Access Compliance Report Public Rights-of-Way (Curb Ramps)

Intersection ID: 46733 Main Street: DARCY_HOPKINS_DR Cross Street: BEAVER_BROOK_WY Location: NW

ADA ID: 035CDF3E7824 Ramp Type: PerpDiag Initial Pass/Fail: Fail Overall Compliance: No Severity Score: 8.75

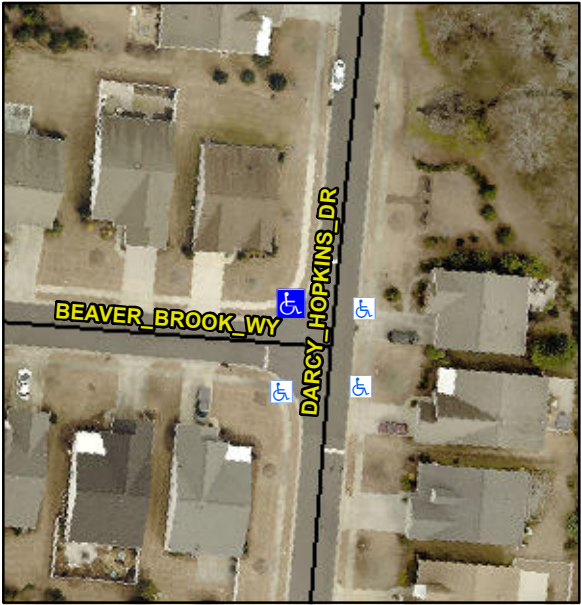
PROW/ADA:
R304.5.1

Compliance	Description	Data	Compliance	Description	Data
N/A	Ramp Length (in)	47.0	Yes	Ramp Slope (%)	7.5
No	Ramp Width (in)	36.0	Yes	Ramp XSlope (%)	1.1
N/A	Flare Type LT	N/A	N/A	Flare Type RT	N/A
N/A	Flare Slope LT (%)	N/A	N/A	Flare Slope RT (%)	N/A
N/A	Flare Traversable LT?	N/A	N/A	Flare Traversable RT?	N/A
N/A	Landing Length (in)	N/A	N/A	DWS Provided?	N/A
N/A	Landing Width (in)	N/A	N/A	DWS Contrast?	N/A
N/A	Landing Slope (%)	N/A	N/A	DWS Length (in)	N/A
N/A	Landing X Slope (%)	N/A	N/A	DWS Full Width?	N/A
N/A	Landing Curb? (Y/N)	N/A	N/A	DWS Offset (in)	N/A
N/A	Shared Landing?	N/A			
N/A	Gutter Ponding?	N/A	N/A	Gutter Slope (%)	N/A
N/A	Gutter Lip Ht (in)	N/A	N/A	Gutter X Slope (%)	N/A
N/A	Painted X Walk1?	No	N/A	Painted X Walk2?	No
	X Walk 1 Direction	To SW		X Walk 2 Direction	To SE
N/A	X Walk 1 Width (in)	N/A	N/A	X Walk 2 Width (in)	N/A
	X Walk 1 Slope (%)	2.7		X Walk 2 Slope (%)	0.6
	X Walk 1 X Slope (%)	0.1		X Walk 2 X Slope (%)	0.1

Possible Solutions:
Remove & Replace Curb Ramp With Two New Directional Ramps or Equivalent.
